## REQUEST FOR INFORMATION (RFI)

PROJECT :	BKK2	R.F.I. NO. :	523213-01-RFI-AR-0024
TO :	CTA	ATTENTION :	CTA
SUBMITTED DATE:	19-Jan-26	NEED REPLY BY DATE :	26-Jan-26

SUBMISSION OF :	<input checked="" type="checkbox"/> Q&A	<input checked="" type="checkbox"/> Drawing	<input type="checkbox"/> Document	<input type="checkbox"/> Others (as specified below)
SUBJECT : Request for Information - Confirmation on Wire Mesh Screen Details at Fan Wall Corridors.

**TYPICAL MESHSCREEN LAYOUT**  
SCALE: 1:40

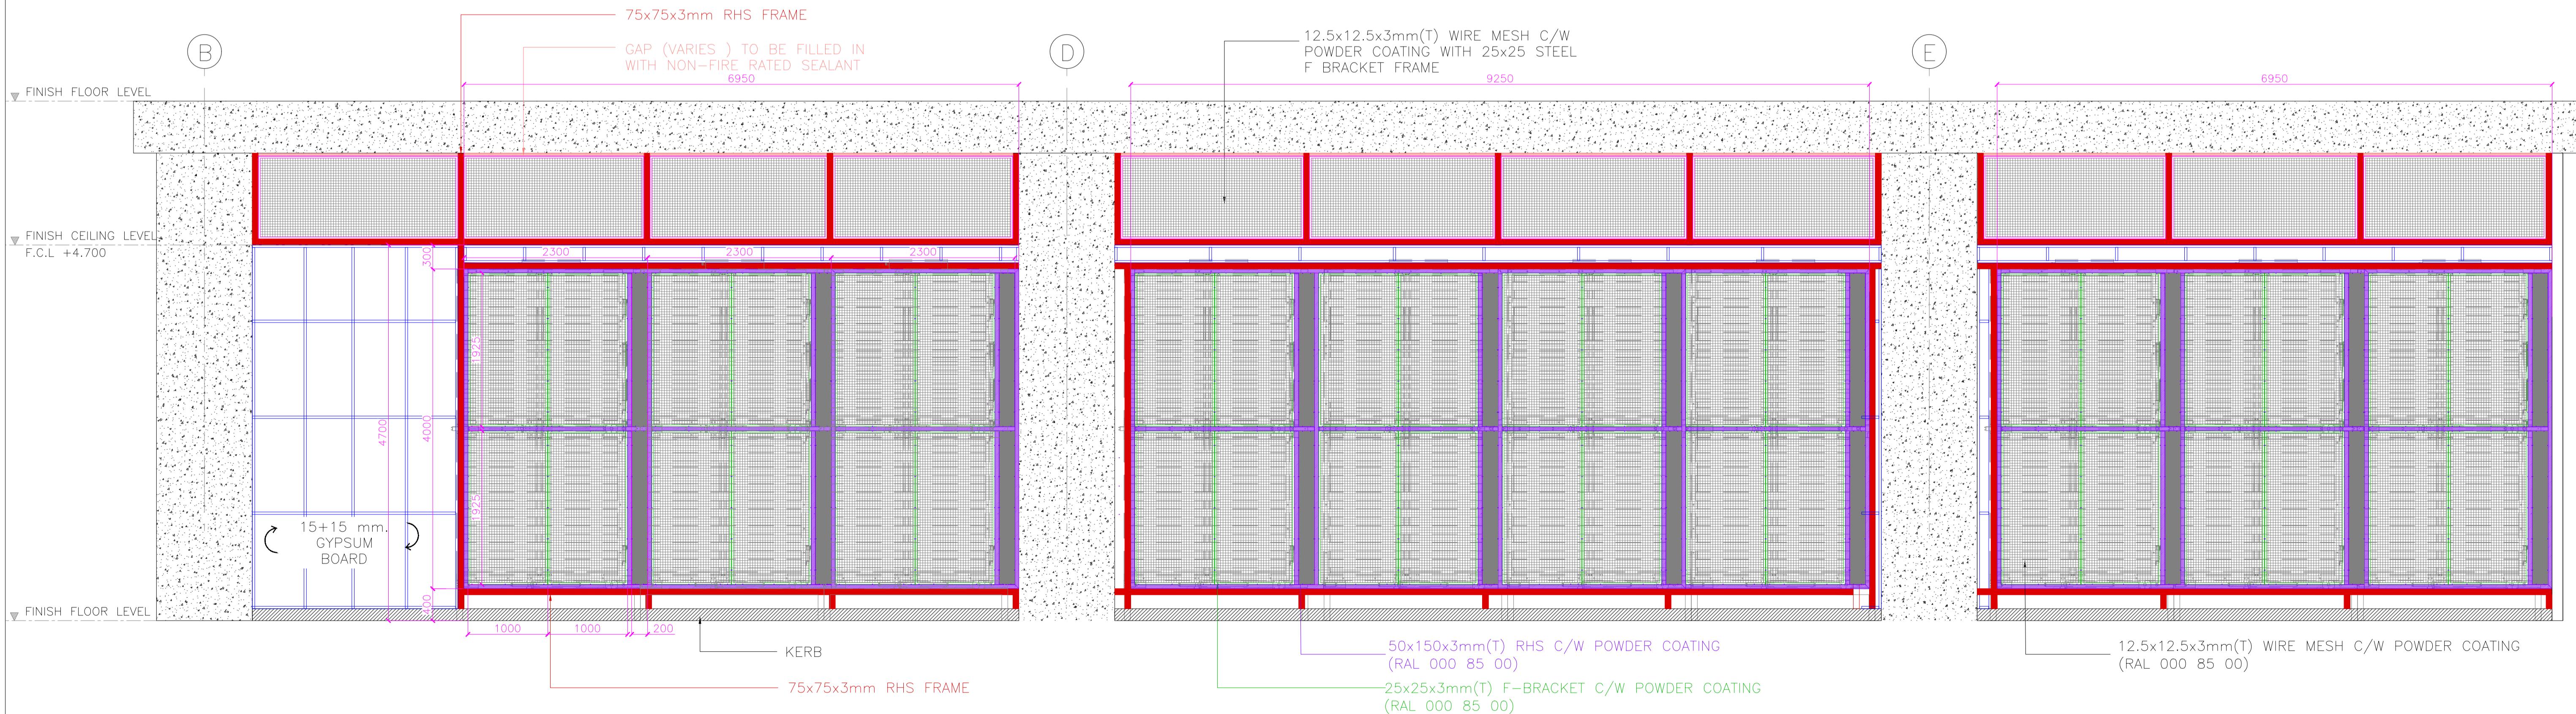
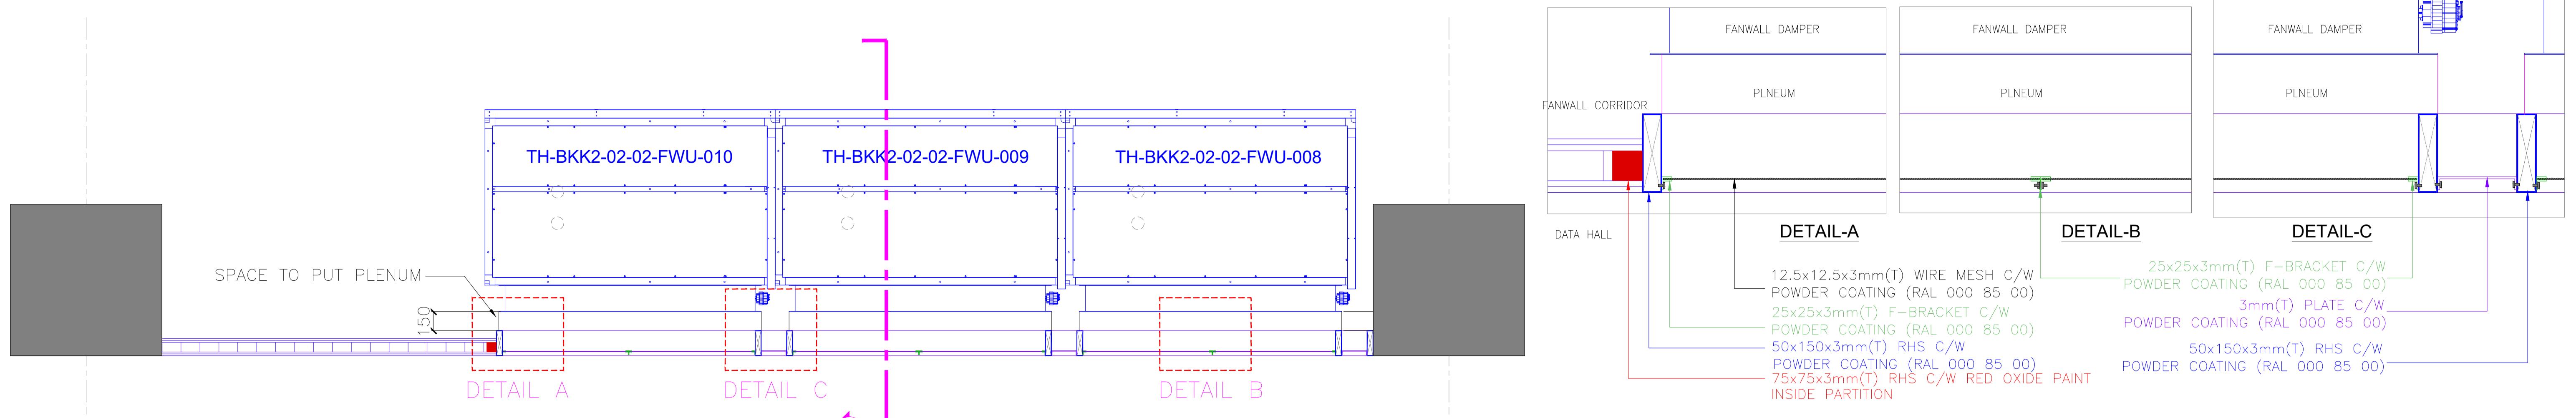
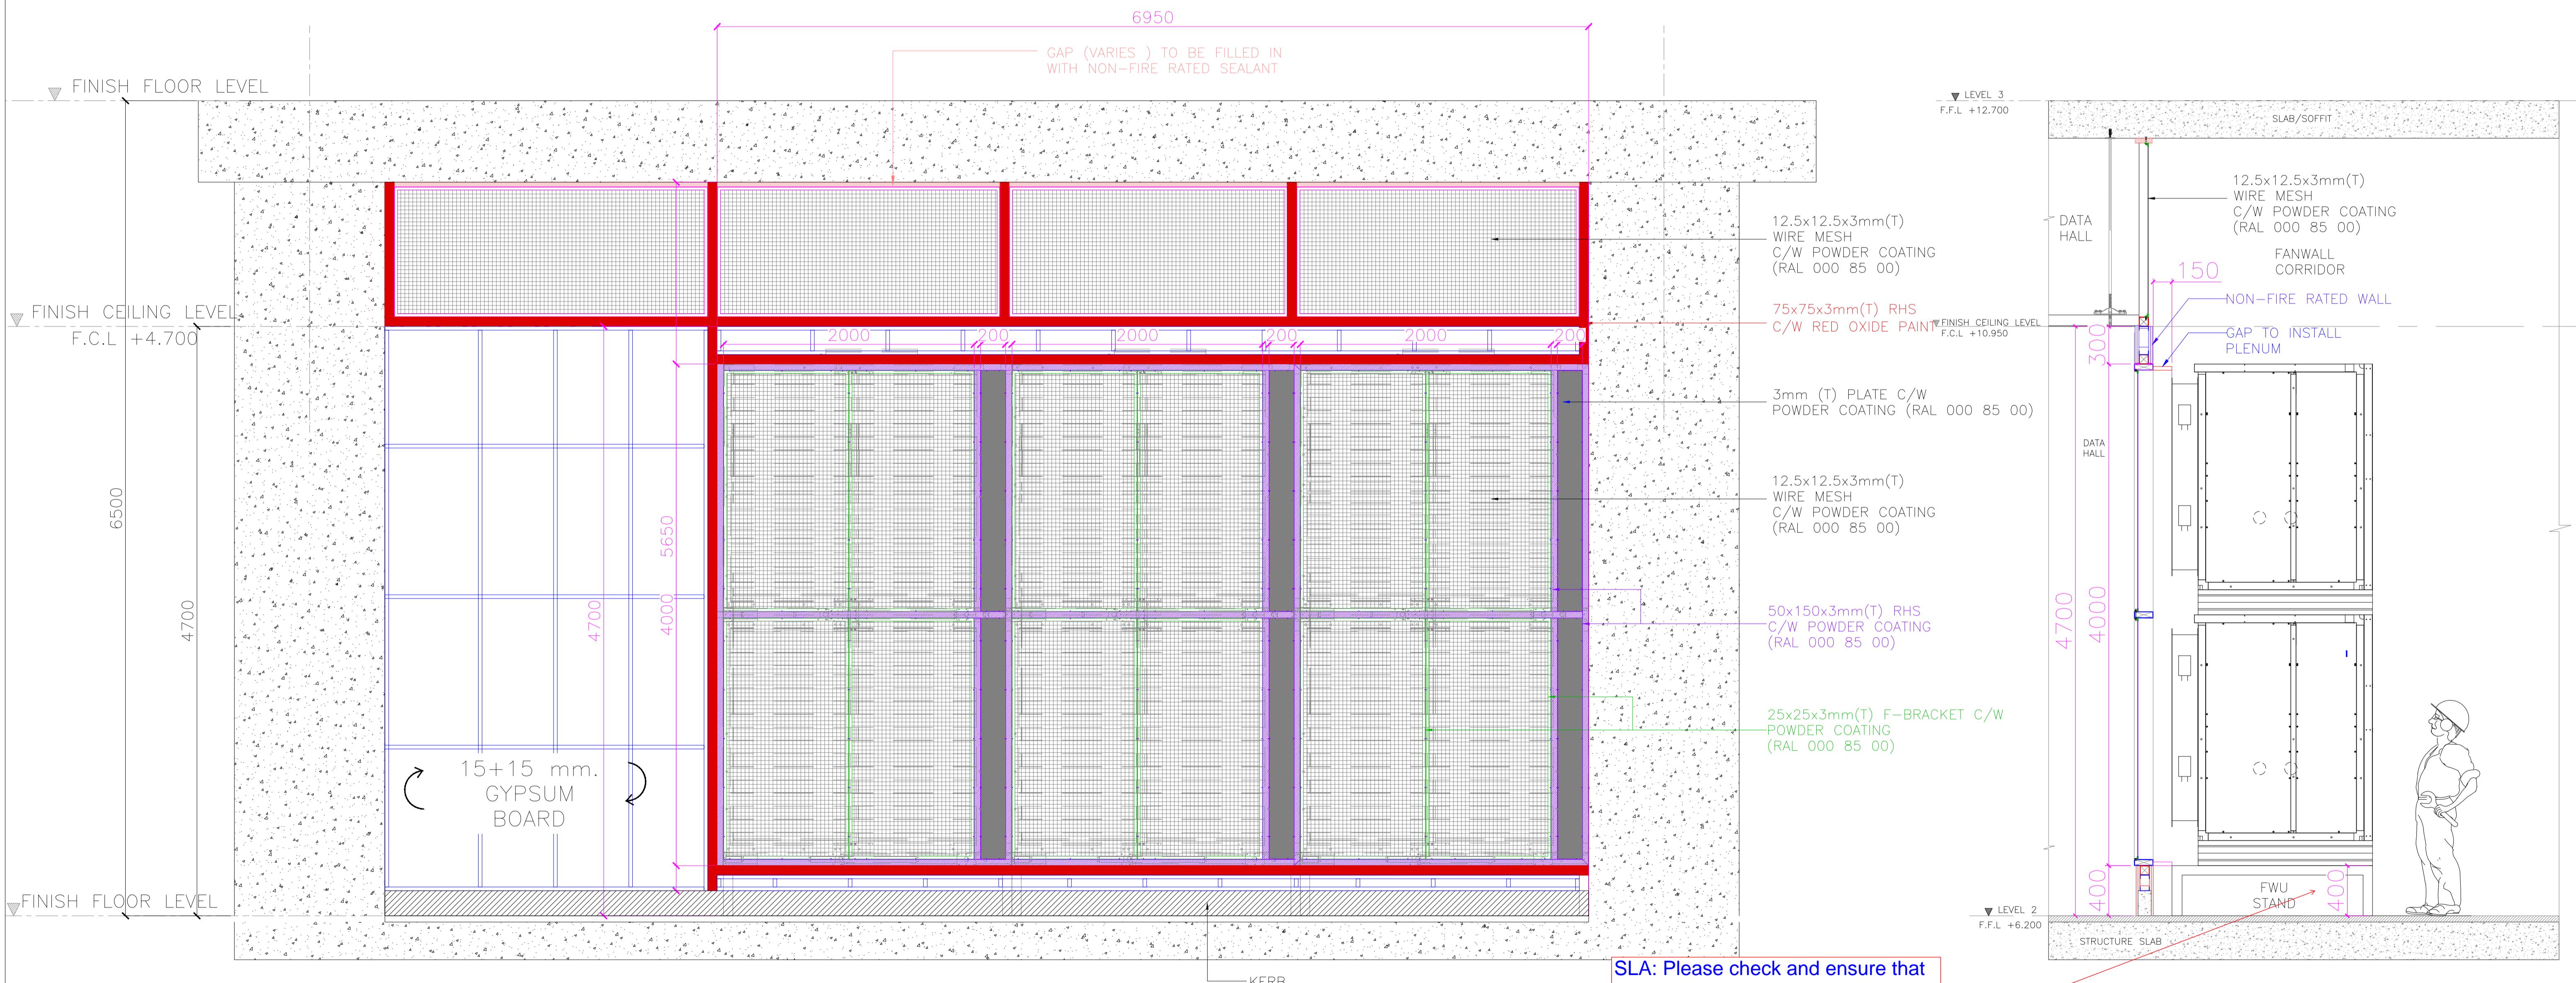
1. Since there is no detailed drawing showing wire mesh screen wall between Data Hall and Fan wall Corridor in tender, GAA Would like to propose wire mesh screen walls details by referring the designs installed in Phase 4 BKK1 Level 6. Please refer the attached file for the details.

GAA Would like to inquire if the proposed designs can be acceptable or not.

SLA: The wire mesh between data hall and fan wall corridor shall follow detail on AR-3316.

SCALE : 1:20

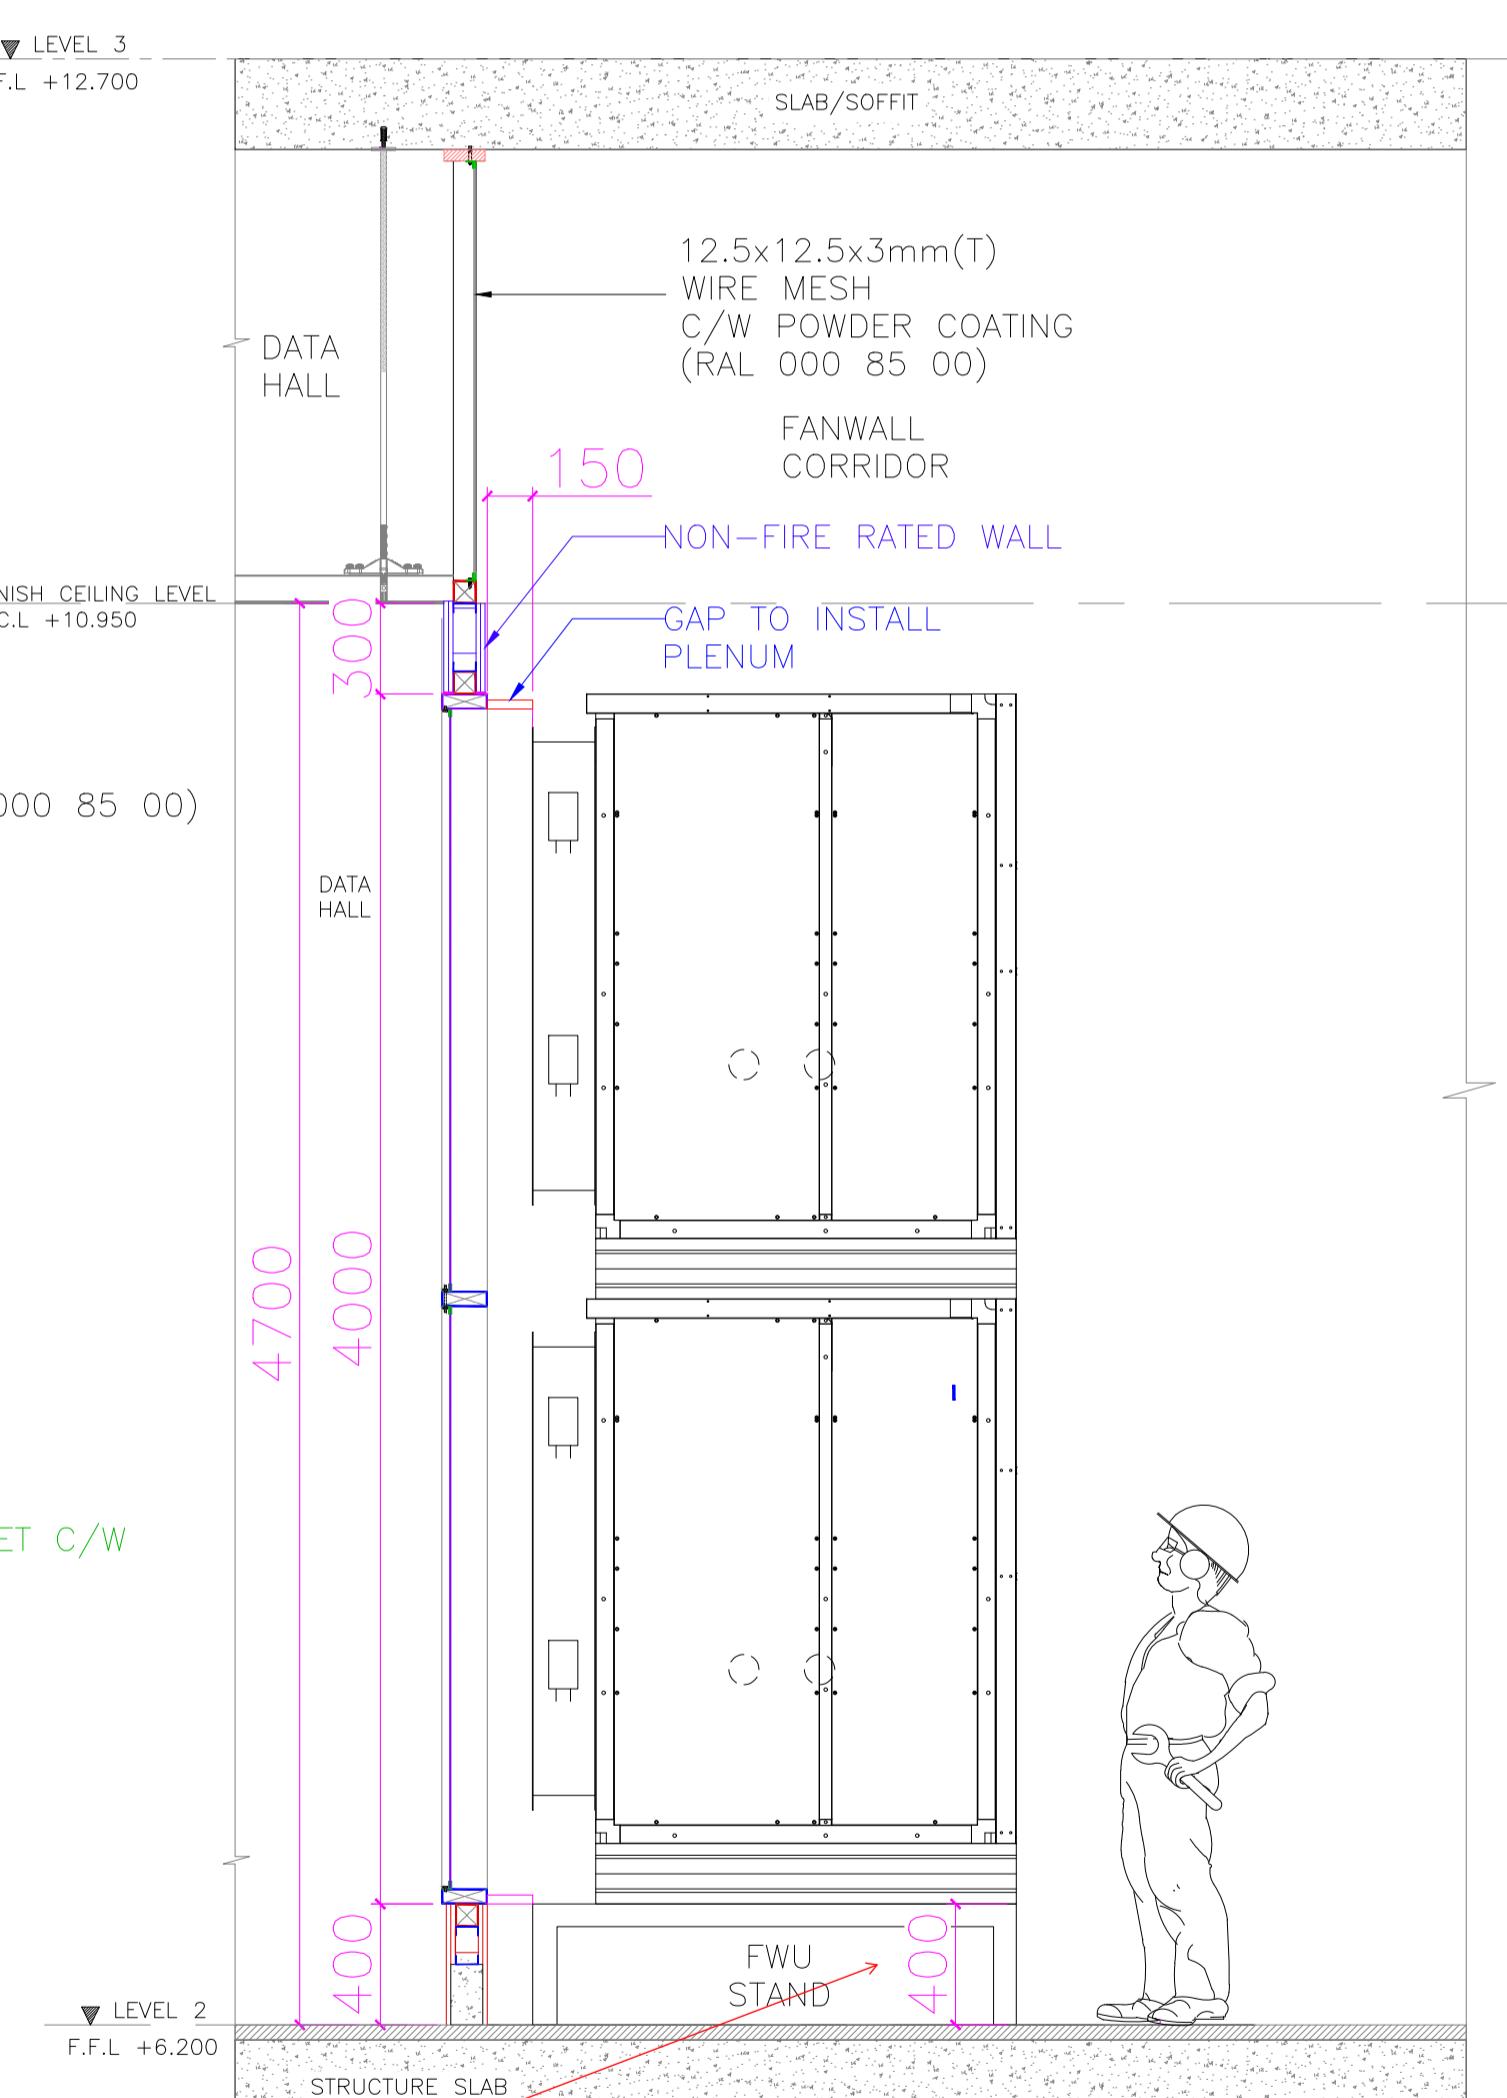
**SLA:** Please check and ensure that the space is sufficient for the condensation with slope to the drain riser at grid line B. Our detail on AR-3316 show 600mm high (RC kerb + gypsum board partition).
